Staff Report & Recommendation

Historic Preservation Board

SUBJECT: HPB17-0116, **433 Lincoln Road.**

The applicant, 433 Lincoln Road, LLC, is requesting a Certificate of Appropriateness for the introduction of a signage program for the building.

Example of a sign on the 420 Lincoln Road Building

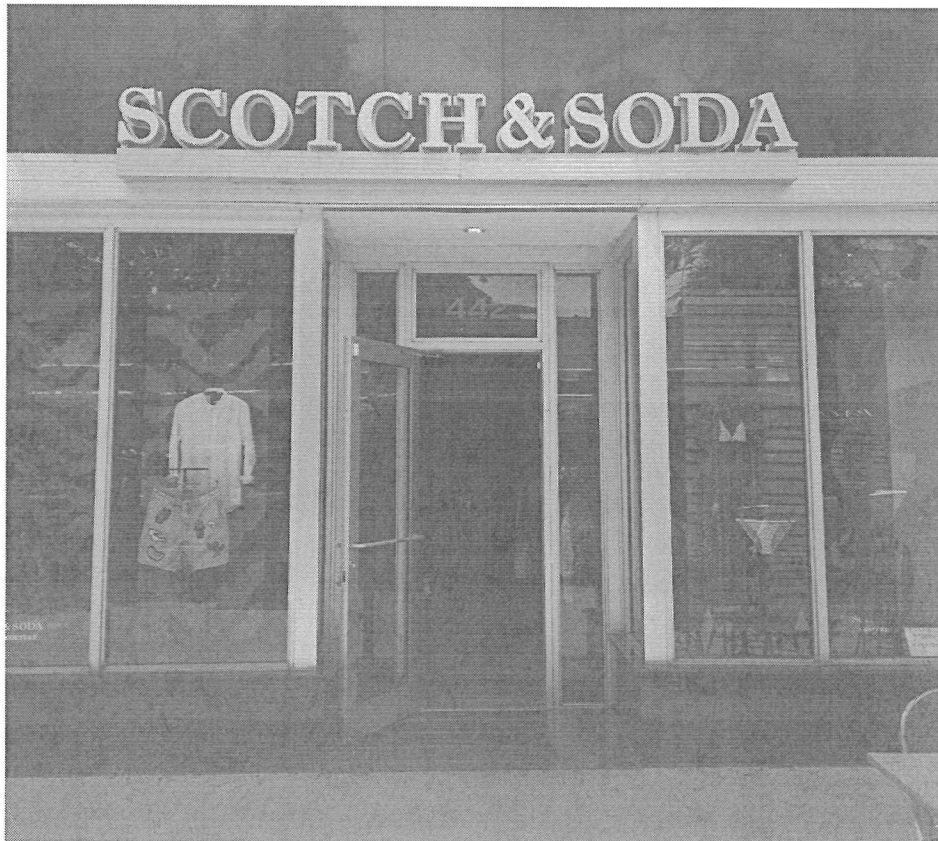
The applicant is currently proposing a signage program that includes brushed aluminum reverse channel letters mounted on top of a raceway. This raceway is proposed project from the existing metal trim above the storefront windows. Because the letters are reverse channel (halo lit) a back plate for each letter will be required for the lighting to function properly. Staff would note that a similar signage program has been successfully implemented at the 420 Lincoln Road Building located across the street.

Staff has no objection to the proposed signage program as it has been designed in a manner which will have no adverse impact of the existing Contributing building or the surrounding historic district.

1. Revised elevation, site plan and floor plan drawings shall be submitted and, at a minimum, such drawings shall incorporate the following:
 - a. There shall be no signage, permanent or temporary, installed onto the marble surface of the façade.

- b. All new signage shall consist of clear anodized brushed aluminum reverse channel letters mounted to a similarly finished back plate and the back plate shall trace the shape of each character and shall project no more than one-inch (1") around the character, in a manner to be reviewed and approved by staff consistent with the Certificate of Appropriateness Criteria and/or the directions from the Board.
- c. The projecting raceway shall be constructed of metal consistent with the existing metal trim above the storefront windows, in a manner to be reviewed and approved by staff consistent with the Certificate of Appropriateness Criteria and/or the directions from the Board.
